Report Title:	Stage 2 Road Safety Audit Response Report – Coventry City Council, Clifford Bridge Road, Coventry Cycle Facilities
Date of Report:	September 2025
Document Ref & Revision:	SA5118
Prepared by:	Gill Wharton
On behalf of:	Waterman Aspen

Project:	Binley Cycleway – Clifford Bridge Road Section 7 (Phase 2)
Report Title:	Stage 2 Road Safety Audit Response Report
Prepared by:	
Name:	Louise Colley
Position:	Project Manager (Highway Delivery)
Signed:	
Organisation:	Coventry City Council
Date:	09/10/2025

GG119 Road Safety Audit Decision Log

Bridgeacre Gardens (north) – BCWY/0100/04

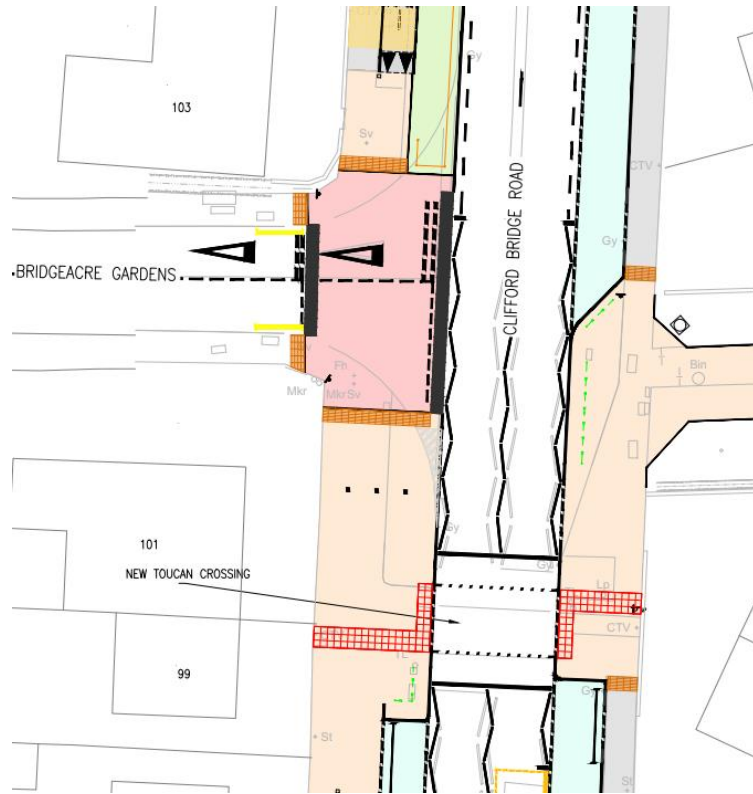
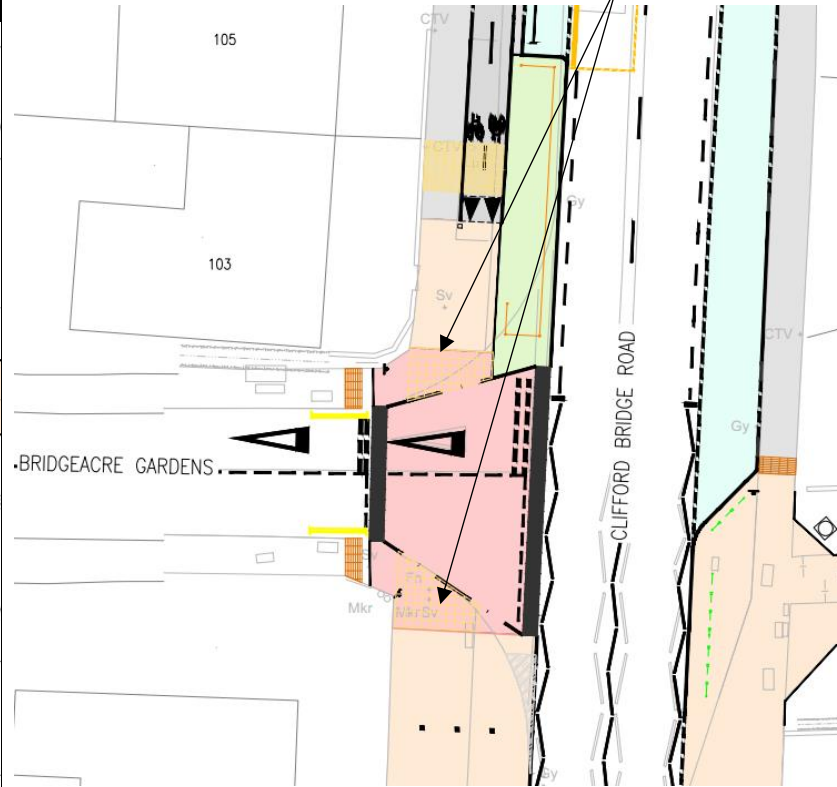
RSA PROBLEM	RSA Recommendation	Design Organisation Response (Choose one of for each response) 1) accept the RSA problem and recommendation made by the RSA team; 2) accept the RSA problem raised, but suggest an alternative solution, giving appropriate reasoning; or 3) disagree with the RSA problem and recommendation raised, giving appropriate reasoning for rejecting both.	Overseeing Organisation Response	Agreed RSA Action
collisions as a result of braking sharply at the last minute when they see a red signal.				
<p>Problem 7.6 Risk of pedestrian confusion and collisions with vehicles</p> <p>The drawings provided show the provision of hazard paving at the raised junctions for the side roads along Clifford Bridge Road for both pedestrians entering the junction from Clifford Bridge Road and from the side roads. Whilst hazard paving is correct on the side roads for pedestrians entering a shared space footway at this location, the Audit Team are concerned that using hazard paving to advise pedestrians that they are entering a live carriageway may cause confusion, increasing the risk of collisions with vehicles.</p>	<p>Stage 2 RSA Recommendation – It is recommended that hazard paving should be used to highlight the start/end of a shared space and blister tactile paving should be used at uncontrolled crossing locations throughout the scheme. It should be noted that pedestrians entering the raised table junctions from the side roads will enter the junction, carriageway side of the tactile paving for pedestrians entering the raised table from Clifford Bridge Road. This means that although the hazard paving is correct to enter a shared space, there is no blister tactile to aid</p>	<p>Stage 2 RSA Design Organisation Response – (1) ACCEPT, buff tactiles to be installed across the length of the carriageway/crossing at the junctions. Please refer to Appendix 1 – Problem 7.6</p>	Update the layout as required to resolve the problem raised.	Design is to be updated as required.

Tactiles changed to buff blisters

Problem 7.8

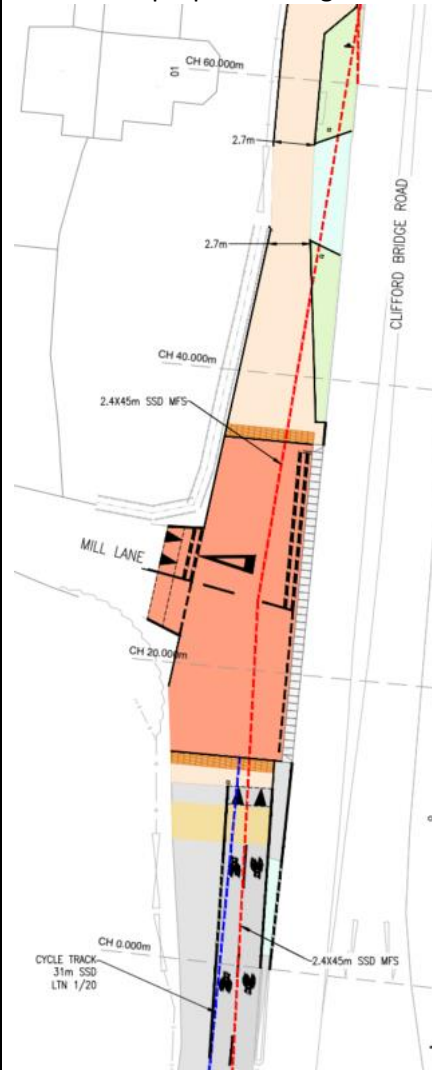
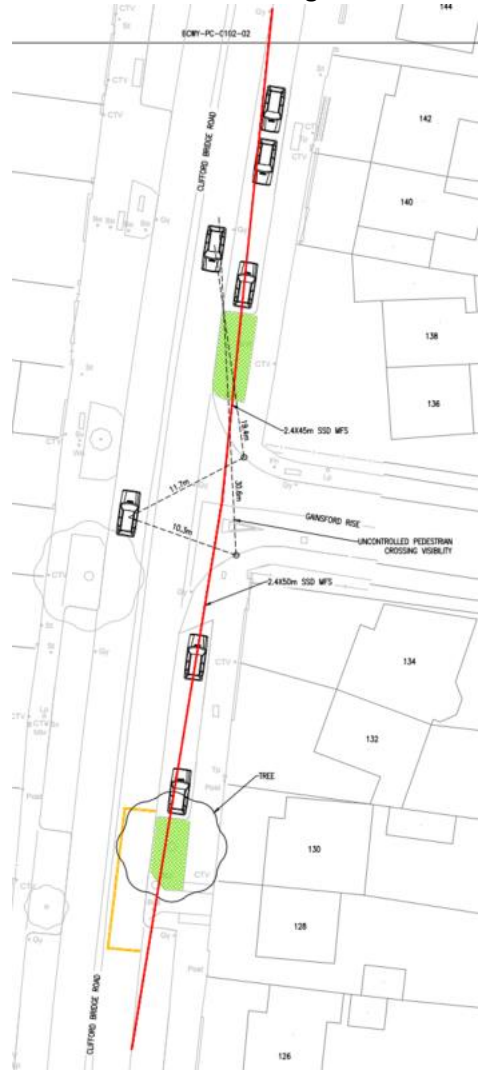
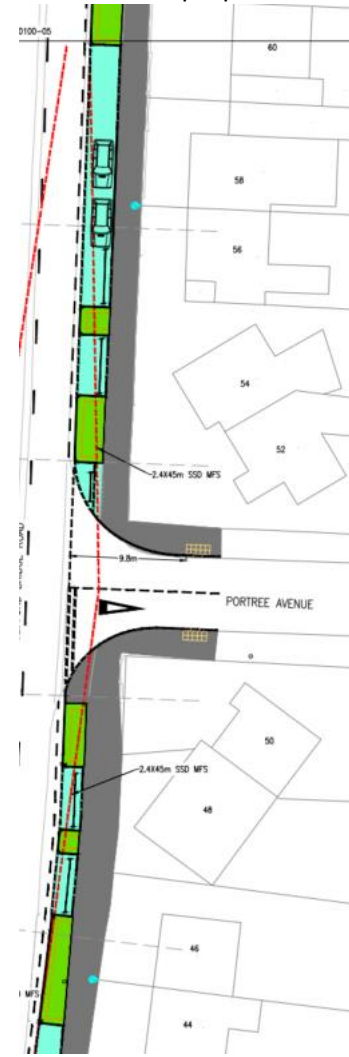
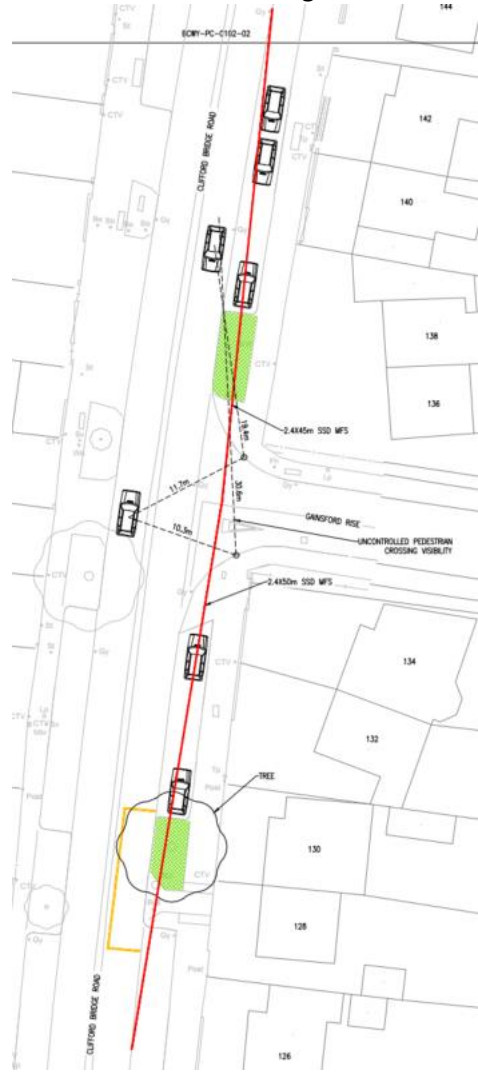
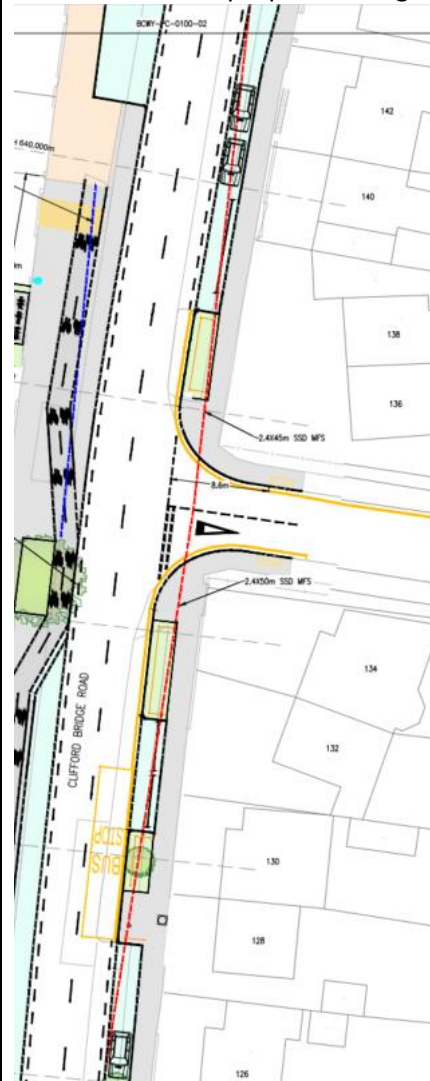
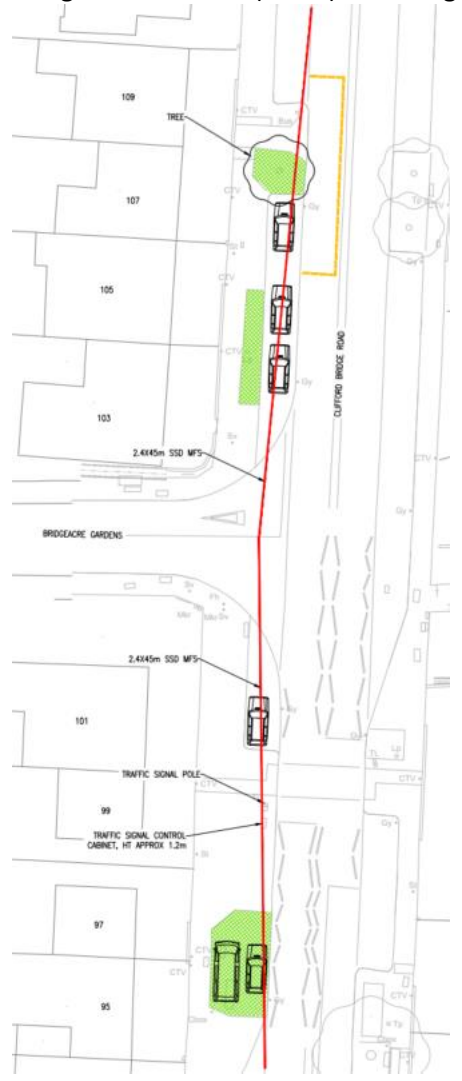
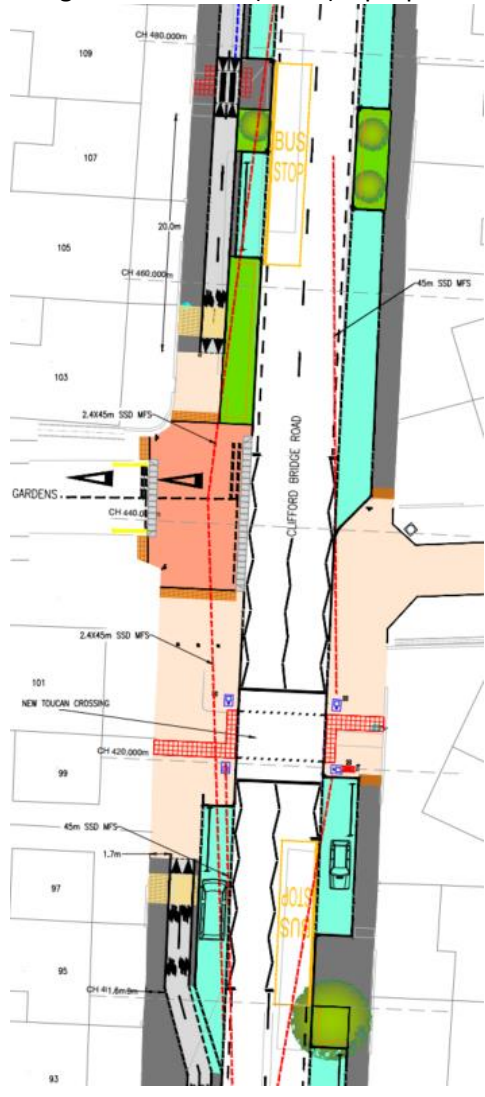
RSA PROBLEM	RSA Recommendation	Design Organisation Response (Choose one of for each response) 1) accept the RSA problem and recommendation made by the RSA team; 2) accept the RSA problem raised, but suggest an alternative solution, giving appropriate reasoning; or 3) disagree with the RSA problem and recommendation raised, giving appropriate reasoning for rejecting both.	Overseeing Organisation Response	Agreed RSA Action
In addition to this, vehicles exiting the junctions overtaking a parked vehicle at these locations may result in vehicle collisions with pedestrians due to intervisibility or masking of the approaching vehicle by the parked one.				
<p>Problem 7.8 Risk of side impact collisions due to restricted visibility The drawings provided show junction visibility splays at the side road junctions to both sides of Clifford Bridge Road. At these junctions the visibility splays appear to go through the proposed parking bays which restricts visibility for vehicles exiting the junctions. Restricted visibility increases the risk of side impact collisions between vehicles exiting the junctions and vehicles on Clifford Bridge Road.</p>	<p>Stage 2 RSA Recommendation – It is recommended that visibility splays should be kept free from obstructions.</p>	<p>Stage 2 RSA Design Organisation Response – (3) DISAGREE, the proposed design offers some improvements to what is existing at the junctions. The proposed design incorporates additional verge, knee railing and 'H' bars (diag. 1026.1) across resident driveways to deter vehicle parking within the visibility splays. Please refer to Appendix I – Problem 7.3, and Problem 7.8</p>	While specific visibility splay criteria may be challenging to meet at this location, the proposed scheme delivers overall betterment by removing verge parking and introducing 'H' bar markings to discourage obstruction. Therefore, given the safety improvement achieved through controlling existing driver behaviour no further action is required.	No further action required.

Portree Road/Cycle way link – BCWY/0101/06

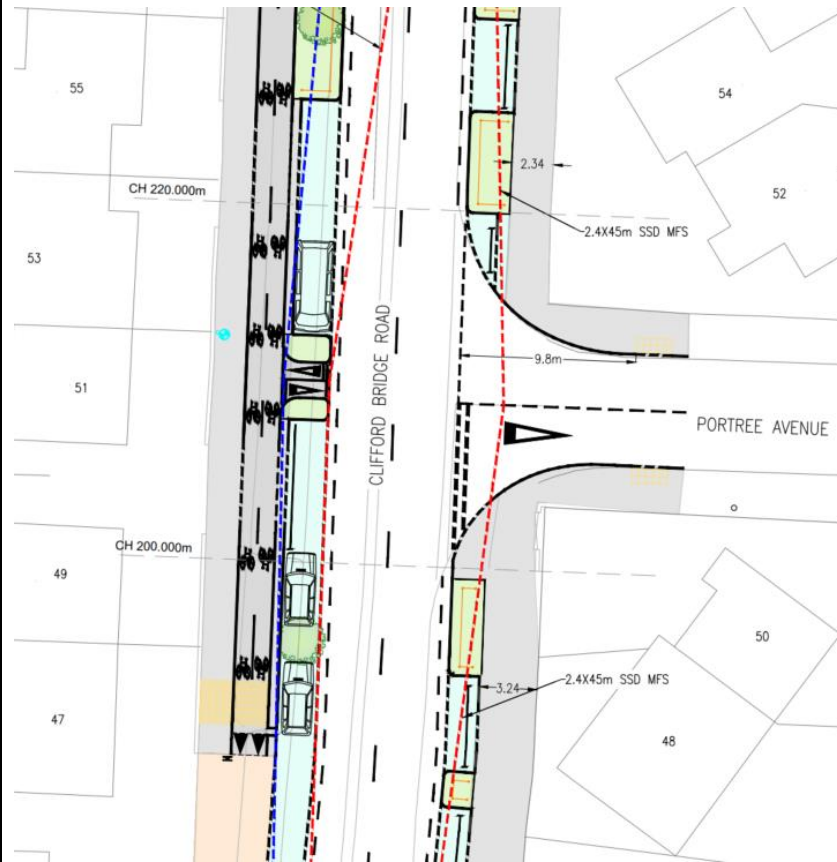
<p>Problem 7.10 Risk of vehicle collisions with cyclists due to restricted visibility The drawings provided show a cycle link from the proposed two-cycleway and Clifford Bridge Road opposite Portree Avenue. A visibility splay has been provided between the cycle link and southbound vehicles. However, no visibility splay has been shown for northbound vehicles. The Audit Team are unsure whether there is</p>	<p>Stage 2 RSA Recommendation – It is recommended that visibility splays should be appropriate and kept free from obstructions.</p>	<p>Stage 2 RSA Design Organisation Response – (3) DISAGREE, the visibility was shown on the drawing but was obscured by drawing objects. The visibility for vehicles to the cycle link is clear of obstructions. Drawing objects have been removed in order show the visibility splay, refer to Appendix 1 – Problem 7.10.</p>	<p>Visibility splays have now been provided and adequate. No further action required.</p>	<p>No further action required.</p>

Visibility splay brought to the front

Bollard widths

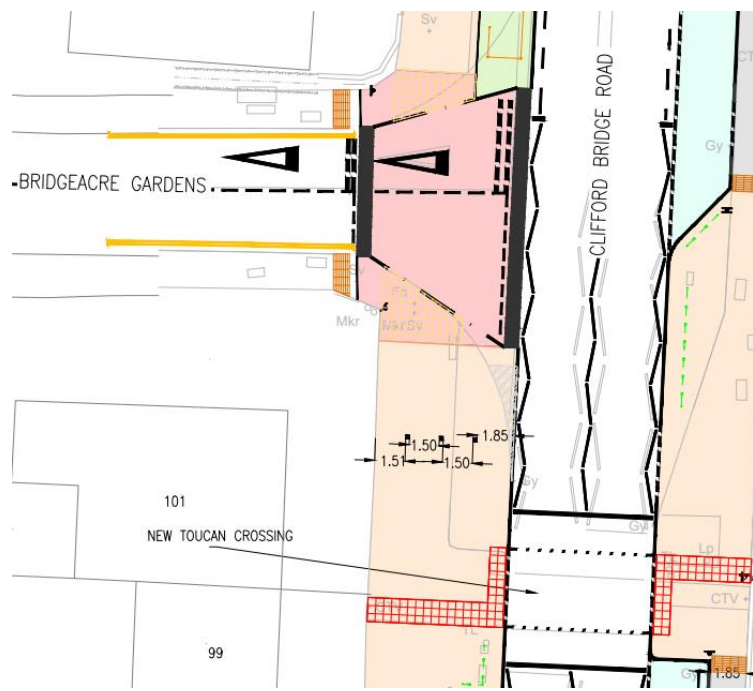
RSA PROBLEM	RSA Recommendation	Design Organisation Response (Choose one of for each response) 1) accept the RSA problem and recommendation made by the RSA team; 2) accept the RSA problem raised, but suggest an alternative solution, giving appropriate reasoning; or 3) disagree with the RSA problem and recommendation raised, giving appropriate reasoning for rejecting both.	Overseeing Organisation Response	Agreed RSA Action
adjacent intervisibility at this point due to parking bays to the south of the link. A lack of appropriate visibility could lead to collisions between vehicles and cyclists pulling out of the link.				
<p>Problem 7.11 Risk of pedestrian injury due to proposed bollards</p> <p>The drawings provided show three bollards across the western footway to the south of Bridgeacre Gardens. The proposed distance between these bollards is not clear to the Audit Team. An insufficient width could result in pedestrian or cyclist injury as a result of colliding with the bollards.</p>	<p>Stage 2 RSA Recommendation – It is recommended that adequate width should be provided between the bollards for both pedestrians and cyclists.</p>	<p>Stage 2 RSA Design Organisation Response – (3) DISAGREE, the bollards were shown on the drawings but without dimensions, they are 1.5m clear spacings between each of the bollards and can be seen on Appendix 1 - Problem 7.11.</p>	<p>Bollard positions been provided and are adequate.</p> <p>No further action required.</p>	<p>No further action required.</p>

Sign layout (BCWY/0100/04)

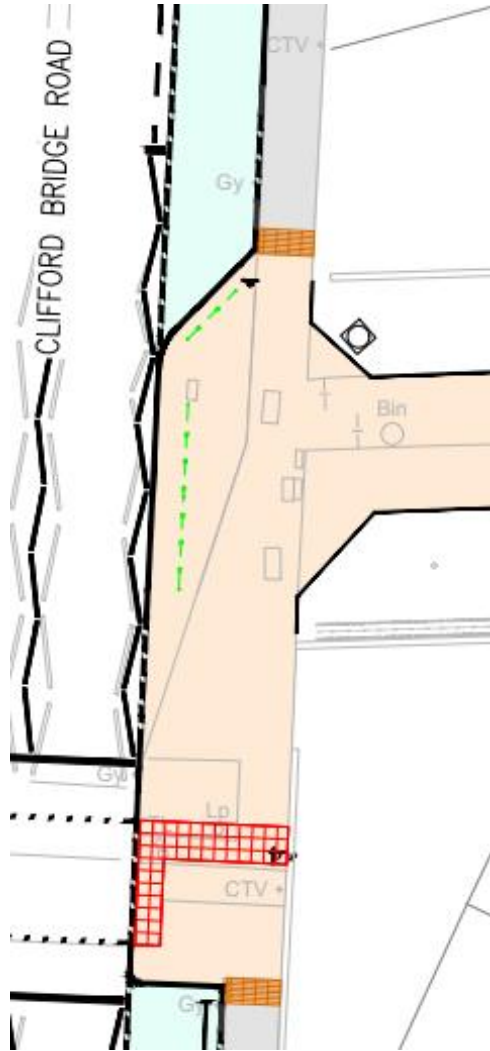
<p>Problem 7.12 Risk of pedestrian collisions with cyclists due to absence of signage</p> <p>The drawings provide do not appear to include any signage to advise pedestrians and cyclists of</p>	<p>Stage 2 RSA Recommendation – It is recommended that shared use and cyclist dismount signs should be installed as required.</p>	<p>Stage 2 RSA Design Organisation Response – (1) ACCEPT, additional signage to be installed to the south of the Toucan crossing. Diag 966 sign to be installed. Please refer to Appendix 1 – Problem 7.12.</p>	<p>Update the layout as required to resolve the problem raised.</p>	<p>Design is to be updated as required.</p>

Additional signs:
south facing

north facing

Existing Road Lining design

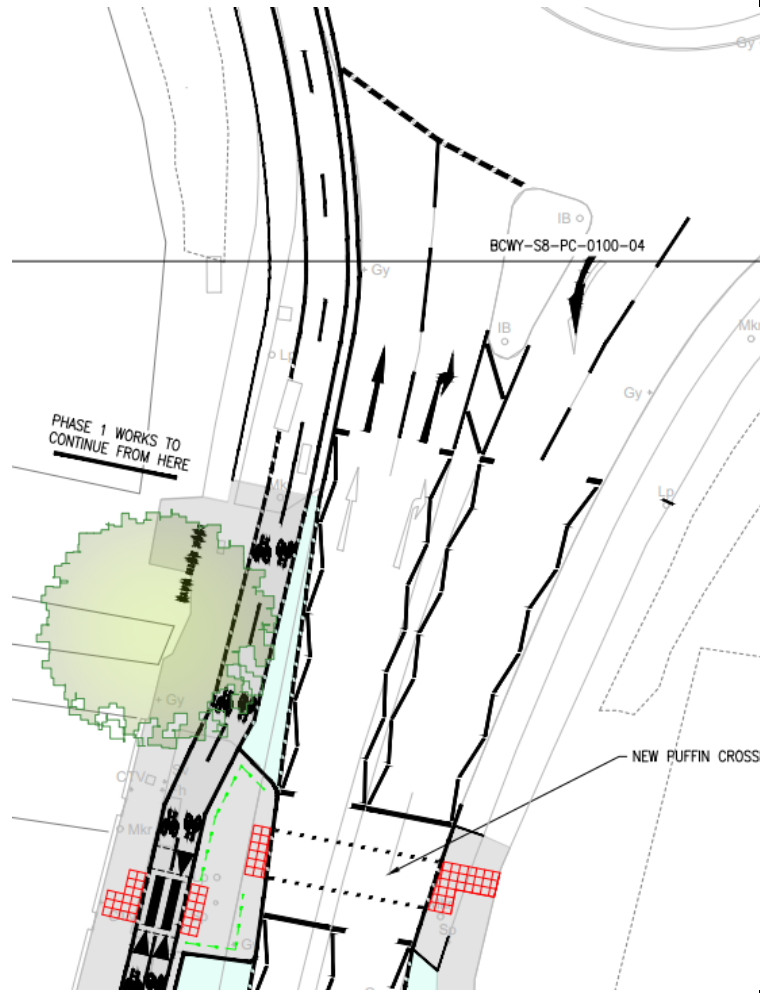
RSA PROBLEM	RSA Recommendation	Design Organisation Response (Choose one of for each response) <ol style="list-style-type: none"> 1) accept the RSA problem and recommendation made by the RSA team; 2) accept the RSA problem raised, but suggest an alternative solution, giving appropriate reasoning; or 3) disagree with the RSA problem and recommendation raised, giving appropriate reasoning for rejecting both. 	Overseeing Organisation Response	Agreed RSA Action
leading to vehicle collisions with pedestrians. This also increases the risk of rear end shunt collisions on the approach to the crossing if drivers brake suddenly for lights should they notice them late.
